ADDENDUM NO. 2

ABRAHAM LINCOLN PARK IMPROVEMENTS - PHASE 2

Capital Improvement Project No. 1462.01

February 2012

DATE: **2/15/2012**
SCALE: **AS NOTED**
edr Job# **09025**
DRAWN BY: **DGP**
FILE NAME: **AD-2-01.dwg**
DRAWING NUMBER: **AD-2-01**

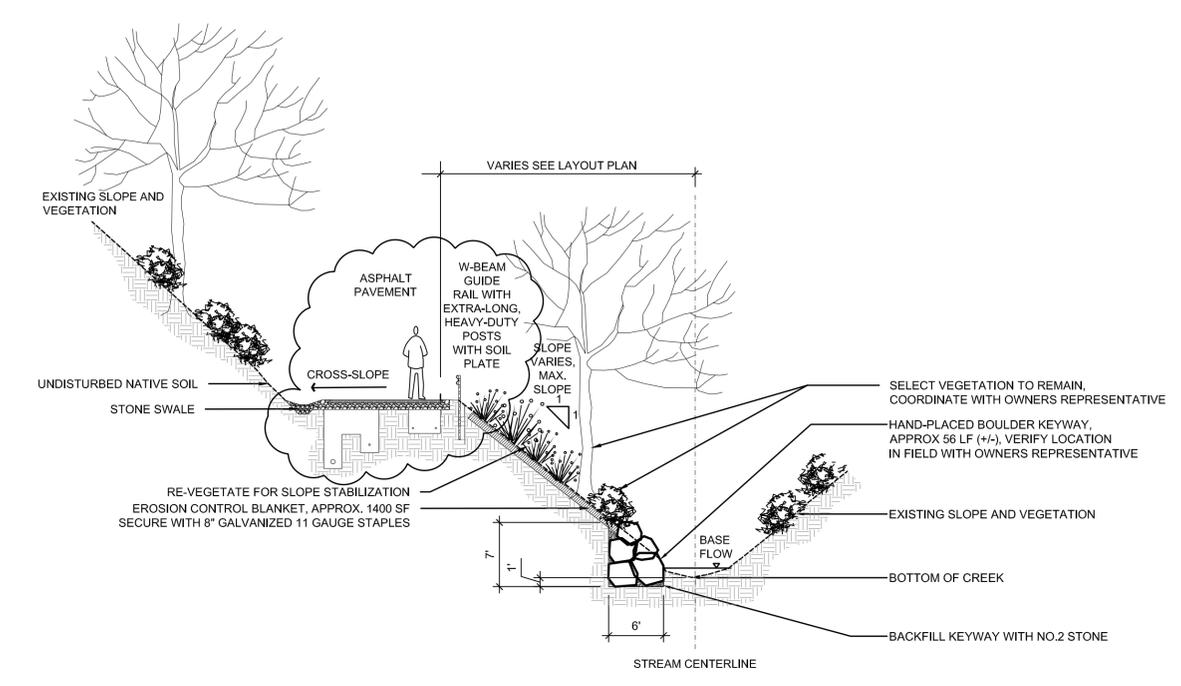
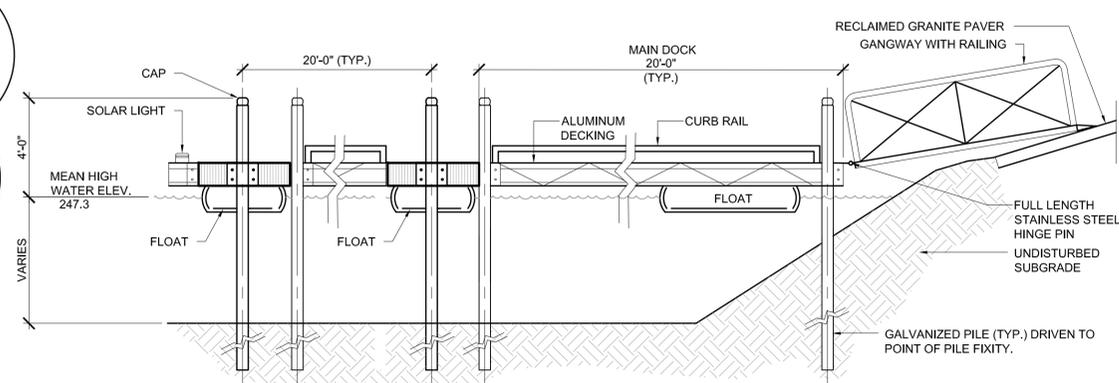
- a) Entire Drawing.

- a) New Drawing – AD-2-01.

2 SLOPE STABILIZATION
Scale: 1" = 10'-0"

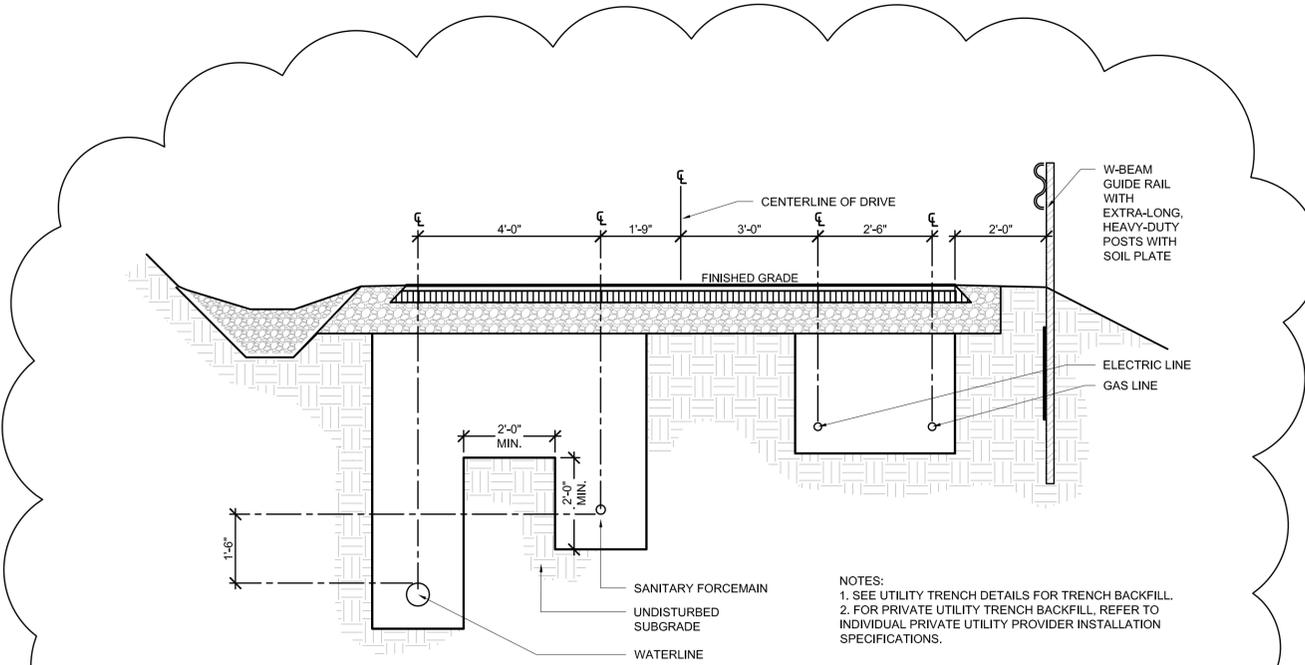
- a) Detail 1 – Slope Stabilization.

- a) Note: Refer to slope stabilization detail on Drawing AD-2-01.

4 CONCRETE RESERVE TANK
 Scale: N.T.S.

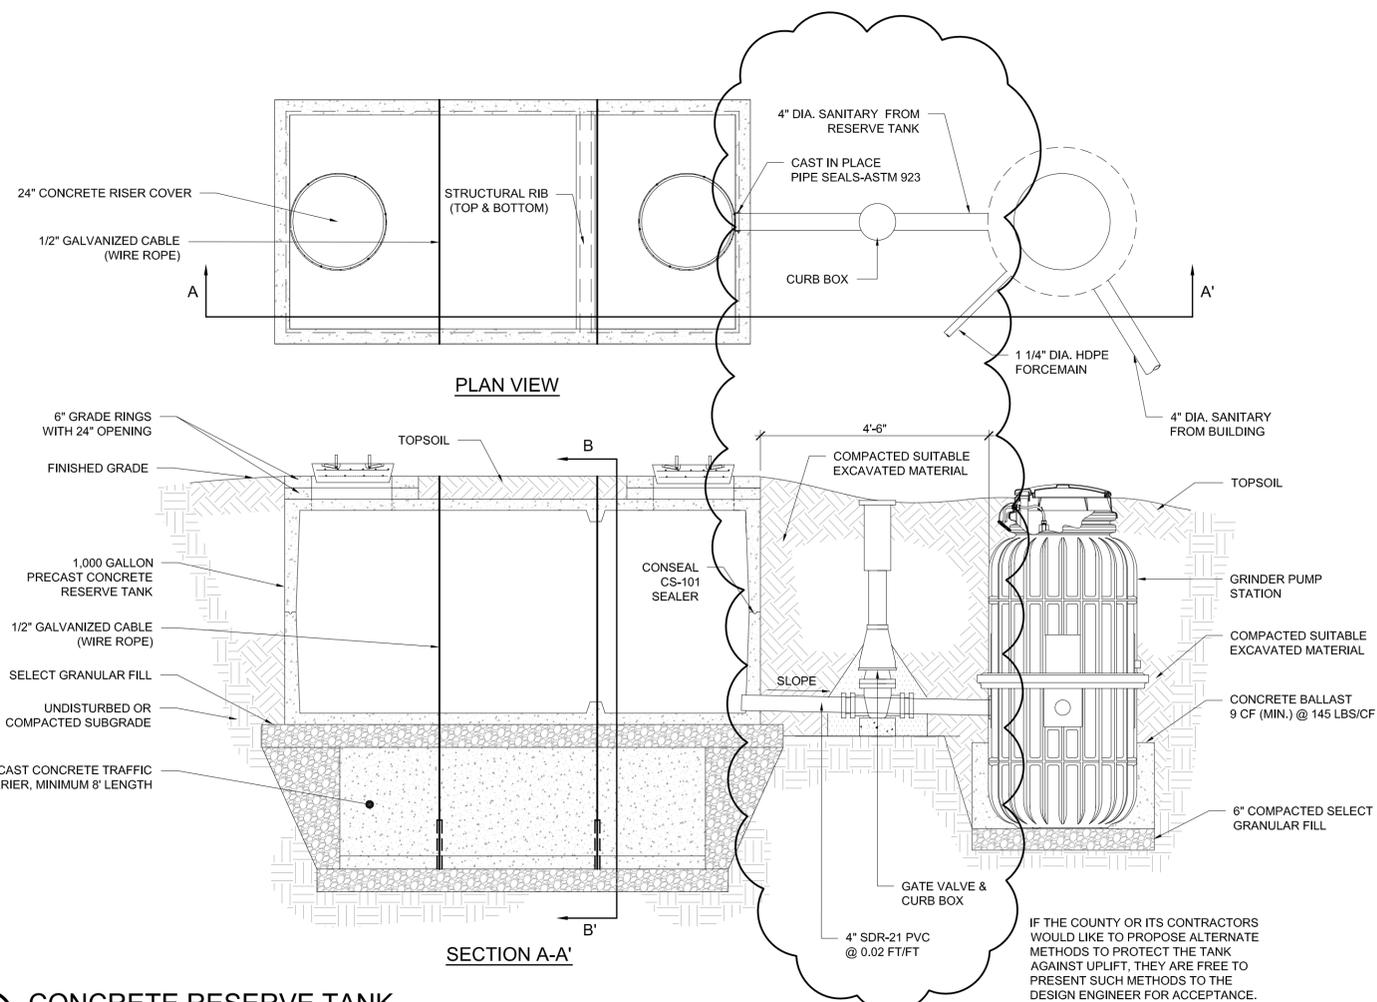
- a) Detail 4 – Concrete Reserve Tank.

- a) Detail 4 – Concrete Reserve Tank on Drawing AD-2-02.
